UNITED STATES PATENT AND TRADEMARK OFFICE

APPLICATION NO.	FILING DATE	FIRST NAMED INVENTOR	ATTORNEY DOCKET NO.	CONFIRMATION NO.
10/040,771	01/09/2002	Christoph Raber	0756 C PCT Cont. US	3604
20676	7590	05/09/2006	EXAMINER	
ALFRED J MANGELS 4729 CORNELL ROAD CINCINNATI, OH 452412433			BONCK, RODNEY H	
			ART UNIT	PAPER NUMBER
			3681

Office Action Summary	Application No.	Applicant(s)	
	10/040,771	RABER, CHRISTOPH	
	Examiner Rodney H. Bonck	Art Unit 3681

DETAILED ACTION

Fig. 2a

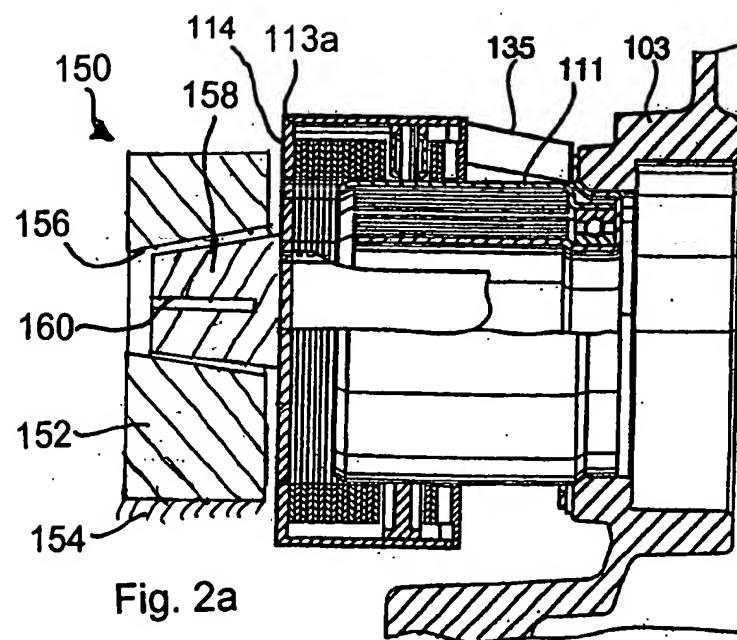
Receipt is acknowledged of the replacement sheets and new sheet of drawings filed March 31, 2006. The proposed replacement sheets are approved for entry. The proposed new sheet is not approved, however, because it includes new matter.

The proposed drawing correction and additions to the description constitute new matter. Accordingly the objection to the drawing for failing to show the subject matter of claim 113 is repeated. It has also been noted that the turbine of claim 72 is not shown.

DO NOT
ENTER
BED
STOP

The drawings remain objected to under 37 CFR 1.83(a). The drawings must show every feature of the invention specified in the claims. Therefore, the turbine of claim 72 and the collet of claim 113 must be shown or the feature(s) canceled from the claim(s). No new matter should be entered.
